Re: Major Projects – New Request for Advice - Yennora Liquid Waste Treatment Plant (SSD-10407)

Please find below comments from Cumberland Council below:

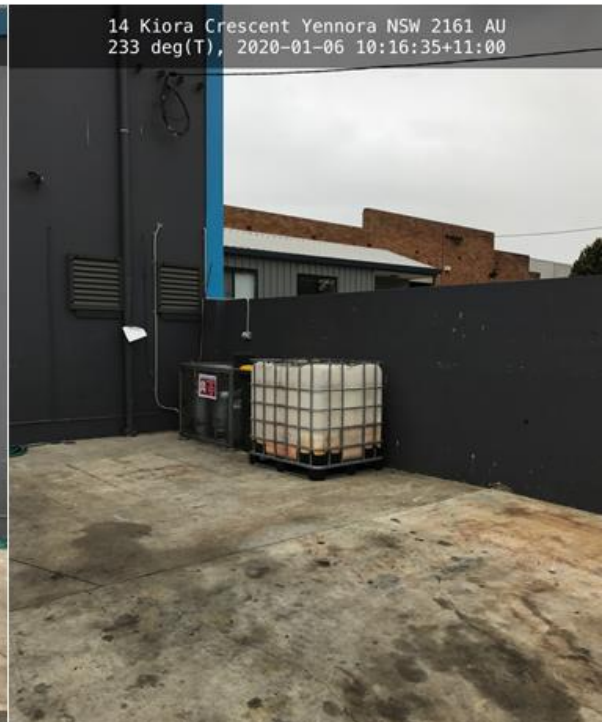
Odours, dust, waste, excessive noise was not observed at the road at the time of the inspection. Upon entering the premises, there was a strong odour present as well as noise from vehicles and machinery in use at the time.

It should be noted that an additional property across the road located at 5 Kiora Crescent Yennora (Lot 10/DP 1233715) was used to store IBC's (large plastic containers) some of which were empty although some of which contained some oils and other products used to service their trucks. The operations manager advised that this area was also used to park and service the business's vehicles as needed. The site consisted of some sealed areas however there were also some unsealed areas which were used to park vehicles. This site is also leased out to two other companies. EHU advises that this site be assessed as a part of the application.
